UNITED STATES OF AMERICA  
BEFORE THE  
FEDERAL ENERGY REGULATORY COMMISSION

Docket Nos. CP15-554-000,  
CP15-554-001,CP15-555-000

COMMENTS ON THE DRAFT ENVIRONMENTAL IMPACT STATEMENT  
FOR THE PROPOSED ATLANTIC COAST PIPELINE AND SUPPLY  
HEADER PROJECT

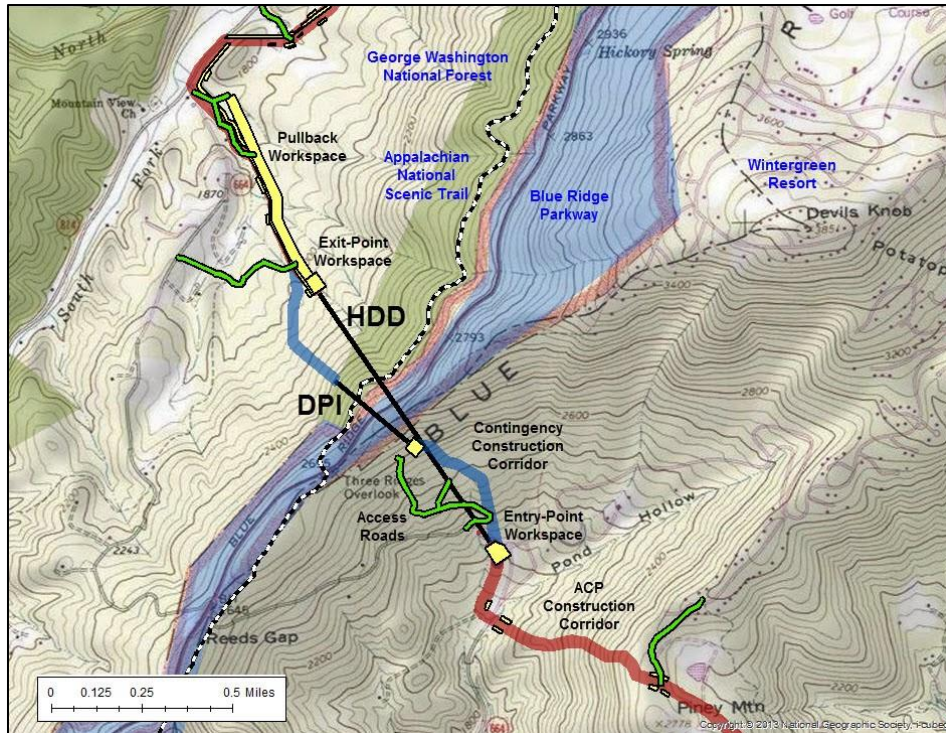
The HDD operation would involve drilling for 4,639 feet at 800 feet below the crest of the Blue Ridge.<sup>496</sup> The contingency DPI operation would involve drilling for 1,396 feet at 200 feet below the crest.<sup>497</sup> Both methods are commonly used for installing pipelines under rivers or other obstacles where the terrain is relatively flat and extremely hard or fractured bedrock is not encountered. The use of either method to drill for long distances through steep mountains is less

FIGURE VII(e) – Extreme pullback required for the proposed Blue Ridge HDD.

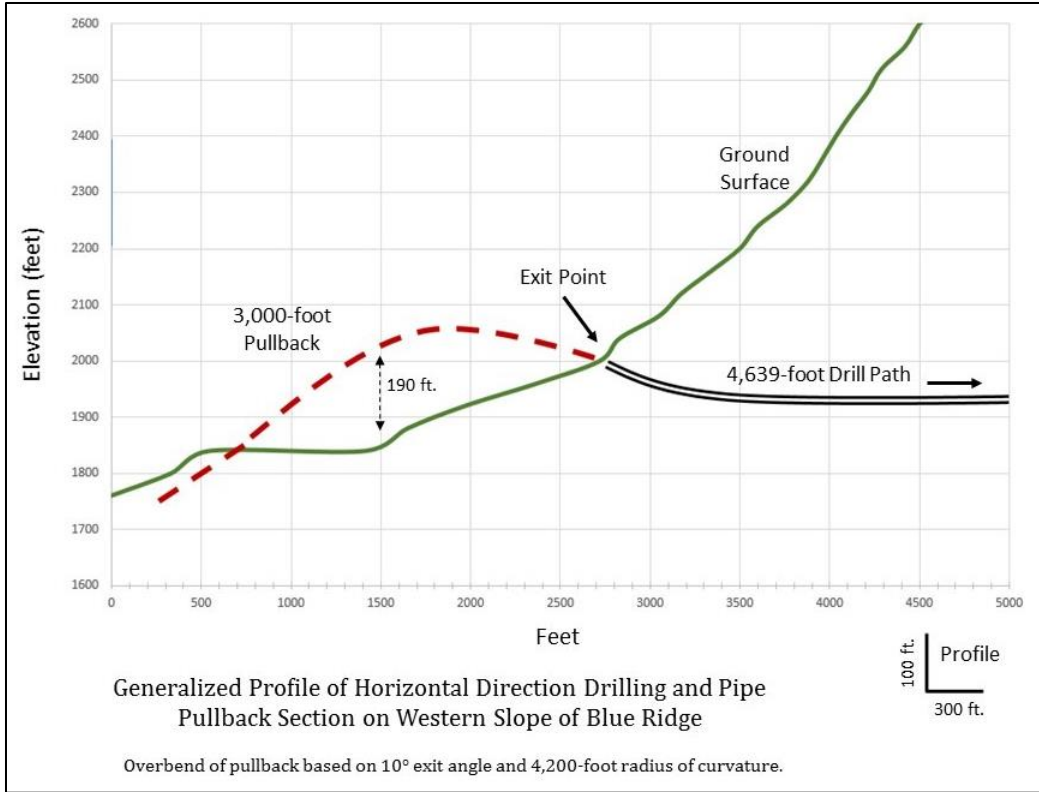
The length of the drilled segment for Atlantic’s proposed HDD is 4,639 feet. The recommended pullback segment would thus be 4,839 feet. However, as indicated in the draft EIS, the length of the workspace available for staging the pipe pullback is only about 3,000 feet, which makes fabrication, hydrostatic testing, and pullback of the recommended single continuous pipe string impossible.

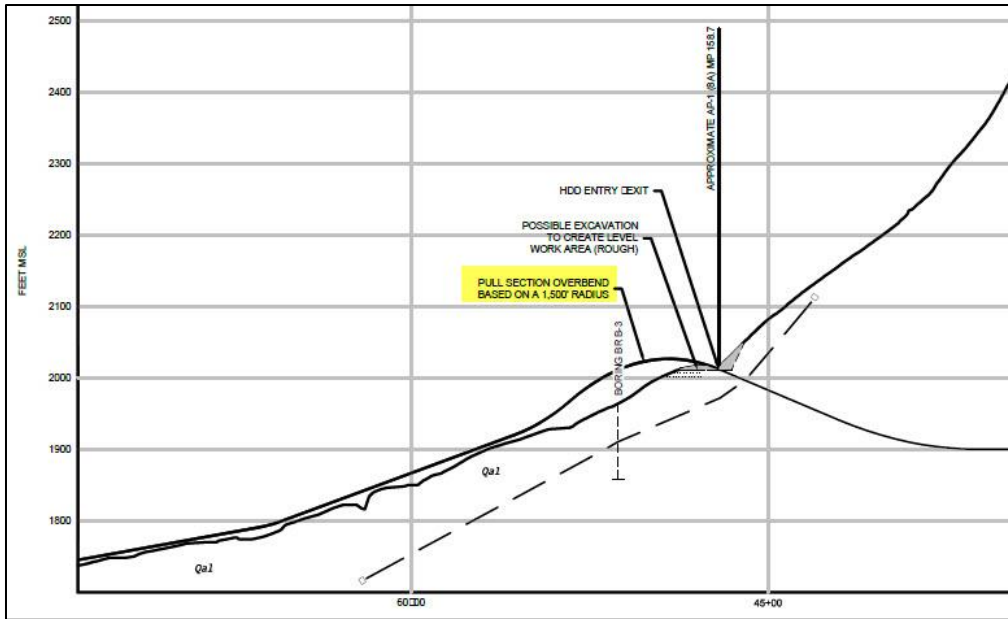
This differs substantially from the correct 4,200-foot bending radius. As indicated in the depiction, a shorter bending radius would require much less lifting of the pipe. The necessary elevation would only be about 50 feet compared to about 200 feet for the longer correct bending radius. The length of pipe suspension would also be much less.

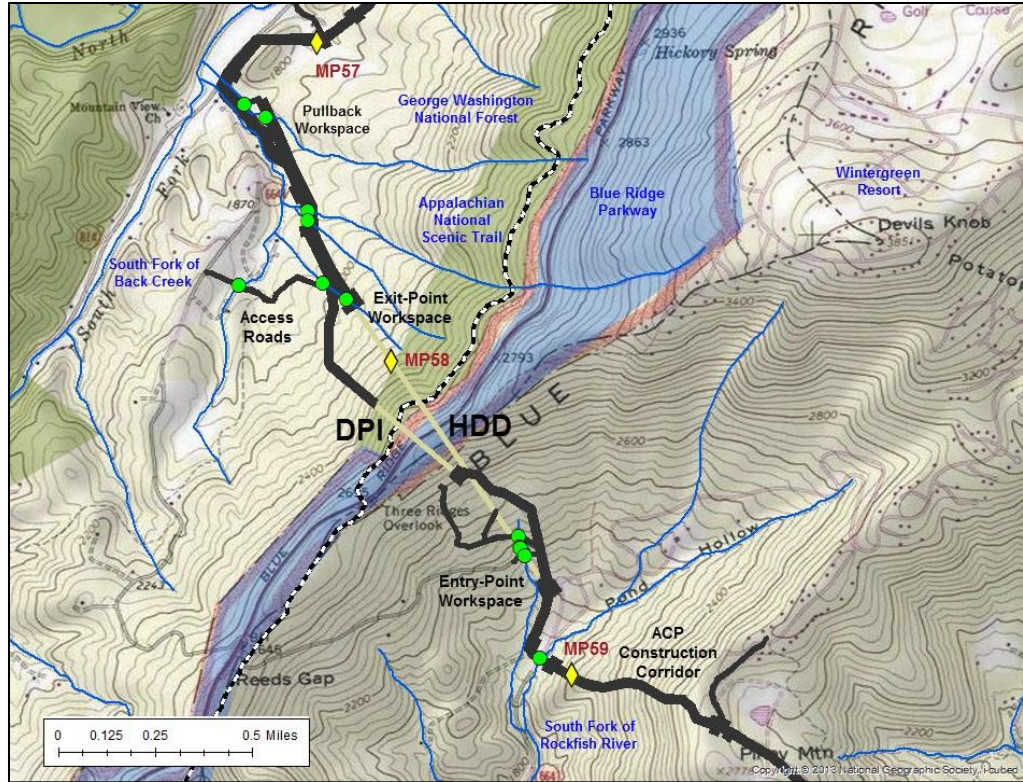
The indicated time-of-year restrictions for these streams limits work from October 1 to March 31 to protect sensitive life stages of aquatic life (see Section 5.1). Adherence to time-of-year restrictions conflicts with Atlantic’s plans for wintertime construction. Information submitted by Atlantic to the National Park Service does not correlate with the stream crossing information depicted in **Figure**

FIGURE VII(i) – Recommended exit-side and pullback pipe fabrication workspace.

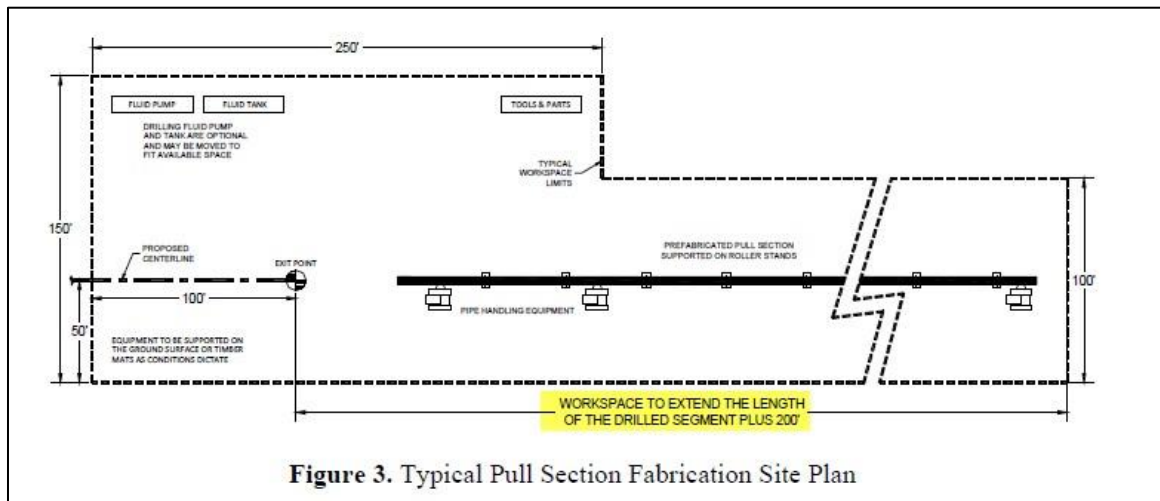
The HDD design report prepared for Atlantic by J.D. Hair & Associates, Inc. includes the following statement on pullback workspace requirements: “It is preferable to have workspace aligned with the drilled segment extending back from the exit point the length of the pull section plus approximately 200 feet. This will allow the pull section to be prefabricated in one continuous length prior to installation. If space is not available, the pull section may be fabricated in two or more sections which are welded together during installation. It should be noted that delays associated with joining multiple pipe strings during pullback can increase the risk of the pipe becoming stuck in the hole. . . . A typical pull section fabrication site plan is shown in Figure 3 [see **Figure VII(i)**]. Where possible, we recommend obtaining workspaces of similar dimensions to accommodate HDD pipe side operations on the ACP Project.”<sup>516</sup>

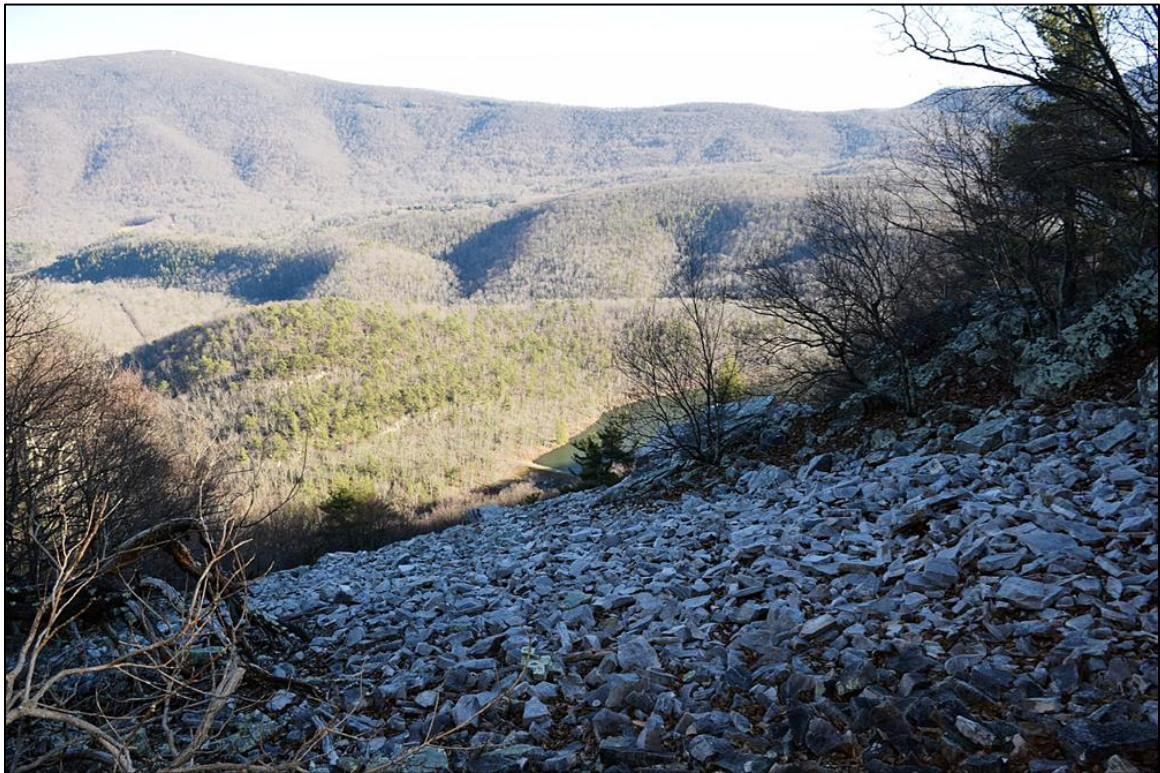
**Figure VII(j)** shows the exit-side and pullback area for the proposed HDD on western slope of the Blue Ridge.

FIGURE VII(k) – Locations of subsurface borings and geophysical surveys conducted for the proposed Blue Ridge HDD crossing. From *Geotechnical Site Investigation Report for Atlantic Coast Pipeline Horizontally Drilled Crossing, Blue Ridge Parkway, Segment AP-1*

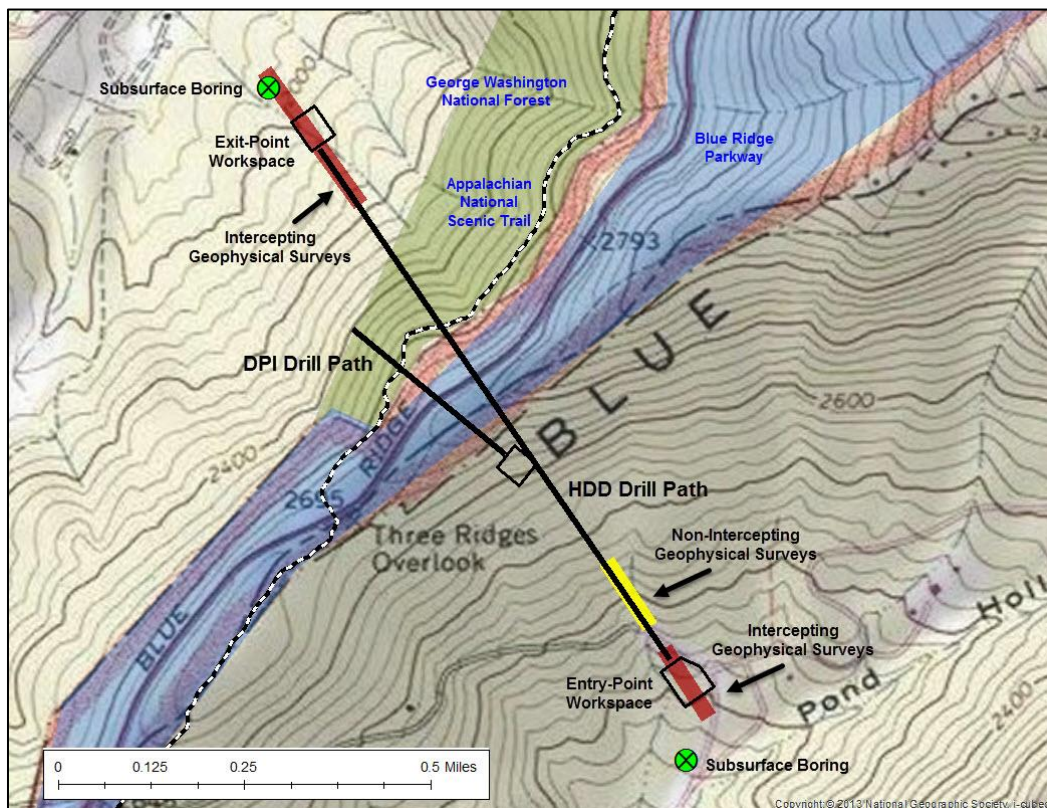
Commission by Atlantic, only two subsurface borings were completed for the proposed HDD, and both were at a lower elevation than the proposed HDD drill path. The only direct physical measurement of geotechnical properties or groundwater in the HDD area was provided by these borings. There were no subsurface borings in the area of the contingency DPI. Additional investigation using geophysical survey methods was limited to areas close to the HDD entry and exit points, covering only a small part of the projected drill path. The locations of the two subsurface borings and other geophysical surveys for the HDD are indicated in **Figure VII(k)**.

FIGURE VII(1) – Interpreted results of geophysical surveys conducted at the entry- and exit-sides of the proposed HDD drill path. (Based on Geophysical Study for a Proposed Blue Ridge HDD Crossing Augusta and Nelson Counties, Virginia, prepared by ATS International, Inc., 4/12/16.)

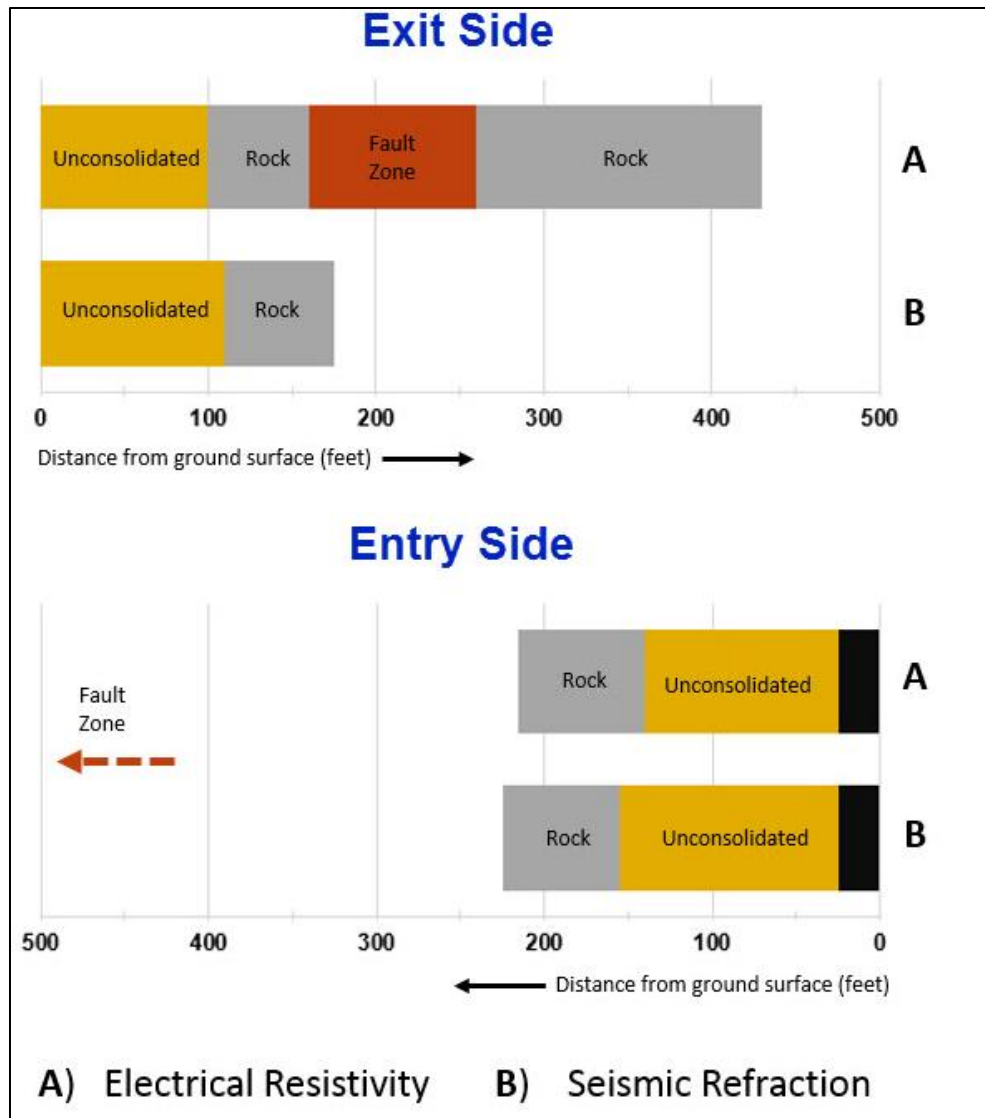
Results are shown for survey sections where imaging intercepted the projected drilling path. The fault zone in the entry-side section was estimated based on non-intercepting surveys, and was estimated to begin at 425-550 feet from the ground surface. The black-colored segments starting at the ground surface on the entry side indicate planned excavation. The total length of the projected drill path is 4,639 feet.

FIGURE VII(m) – Construction-area slope and access-road grade classification for the Blue Ridge HDD and contingency DPI operations area.

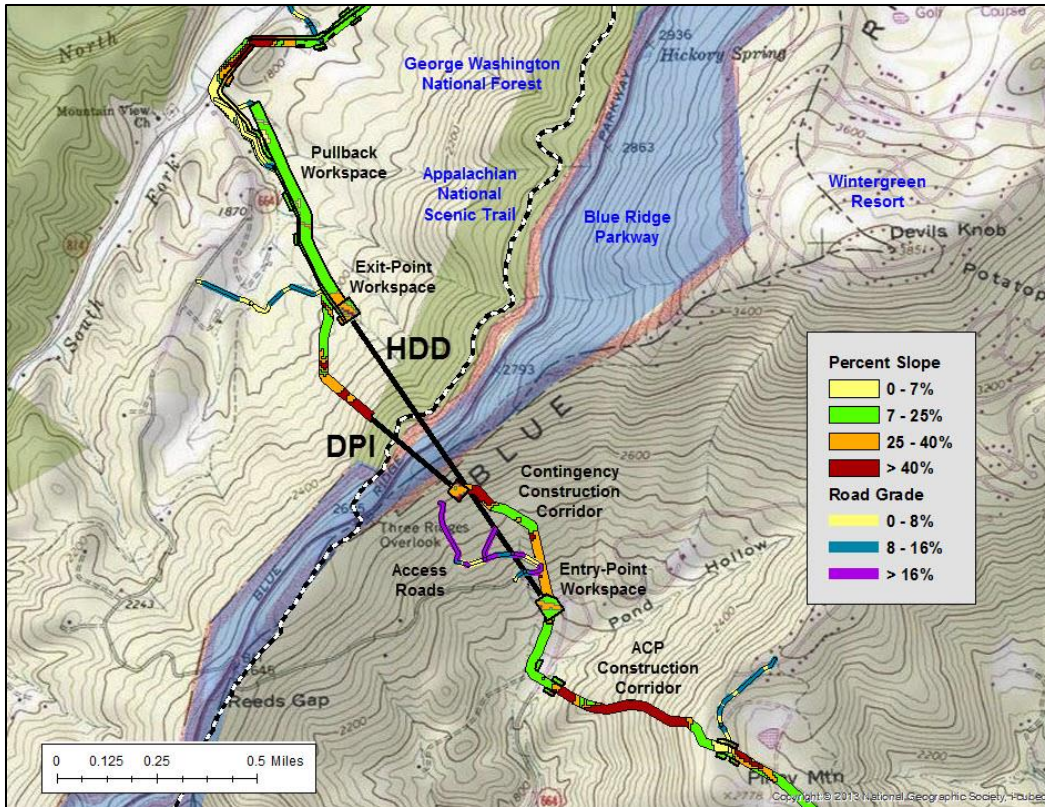
Despite the extensive steep-slope excavation that will be required for the proposed Blue Ridge HDD, the draft EIS does not include site-specific details concerning erosion and sediment control, stormwater management, and slope-failure prevention. This is the case for the broader Atlantic Coast Pipeline project, as well as for the Blue Ridge HDD location. **Figure VII(m)** shows slope classes for the pipeline corridor, workspaces, pullback area, and access roads in the Blue Ridge HDD and contingency DPI areas.
